RE: Response to a coordinated request for additional information required by referral entities in order to properly assess an SDA application, - AP2023/015 – SDA application for a material change of use (MCU) of premises for special industry (50MW hydrogen production facility), substation and major electricity infrastructure in the Gladstone State Development Area (SDA)

RE: EUROA HYDROGEN PROJECT – EUROA CIRCUIT, ALDOGA, QLD 4694
TRAFFIC ENGINEERING RESPONSE TO INFORMATION REQUEST

This letter has been prepared in response to Items 1 to 4 of the Queensland Government's Information Request (Ref: OUT25/5907), dated 11 November 2025, in relation to the proposed hydrogen facility located at Euroa Circuit, Aldoga QLD 4694. The traffic engineering issues being addressed are stated below in *italics* with our response following each item.

Figure 1: Turn Lane Warrant Assessment – 2028 Operational Traffic

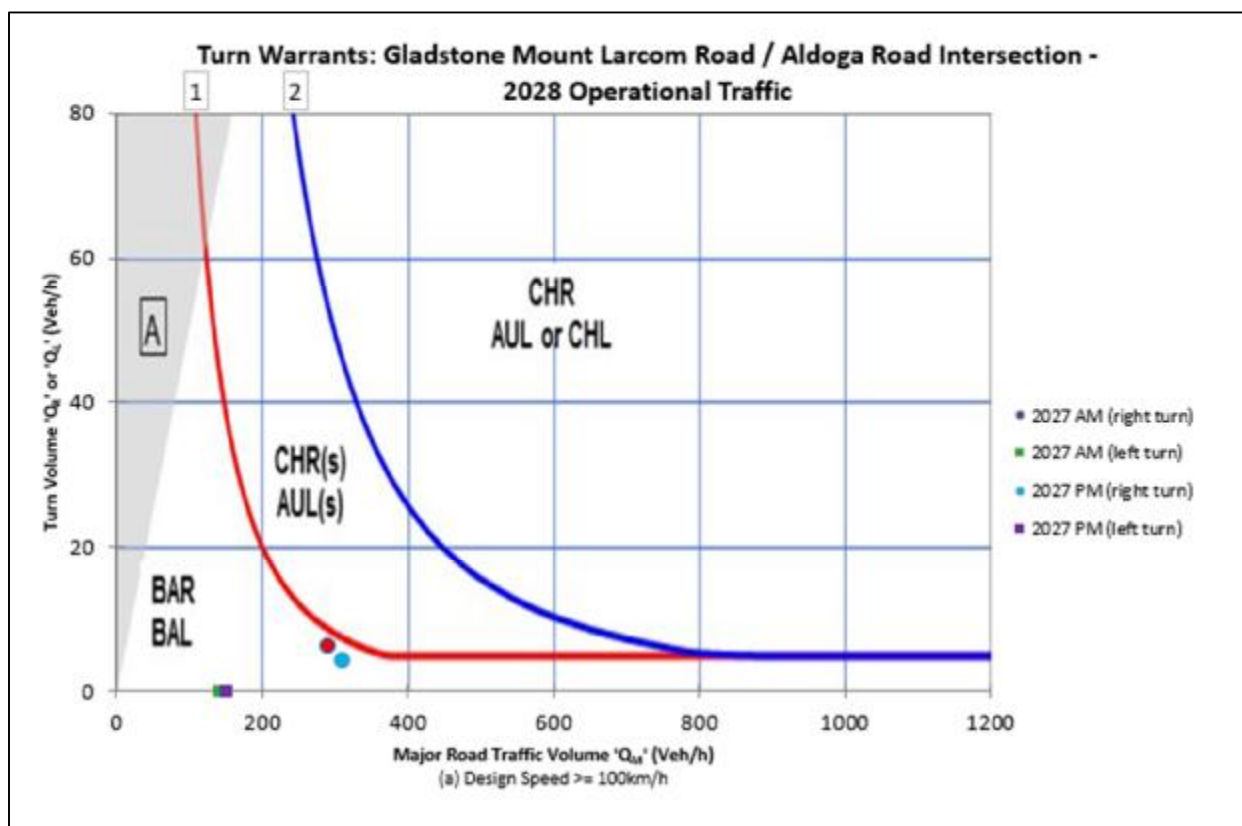
The projected 2027 peak hour right-turn and through traffic volumes at the Gladstone Mount Larcom Road / Aldoga Road intersection require CHR(s) turn treatment, as per the Austroads Guide to Traffic Management Part 6: Intersections, Interchanges and Crossings. However, the TIA does not include a turn warrant assessment or propose any intersection upgrades.

- A turn warrant assessment in line with the Austroads Guide to Traffic Management Part 6: Intersections, Interchanges and Crossings to verify the adequacy of the existing turn treatment
- Identification of any geometric constraints and details of necessary upgrade works
- Confirmation of the required upgrade works through a detailed swept path analysis, following the Austroads Design Vehicles and Turning Path Templates Guide 2013.

A turn lane warrant assessment has been undertaken at the Gladstone Mount Larcom Road / Aldoga Road intersection in accordance with DTMR's Road Planning and Design Manual (RPDM). The posted speed of Gladstone Mount Larcom Road is 100km/h and therefore the assessment has been based on the greater than or equal to 100km/h design speed graph. The result of the and 2028 operational traffic design scenario is shown below in Error! Reference source not found..

The turn lane warrant assessment as shown in Error! Reference source not found. does not require any additional mitigation measures for the 2028 operational traffic scenario.
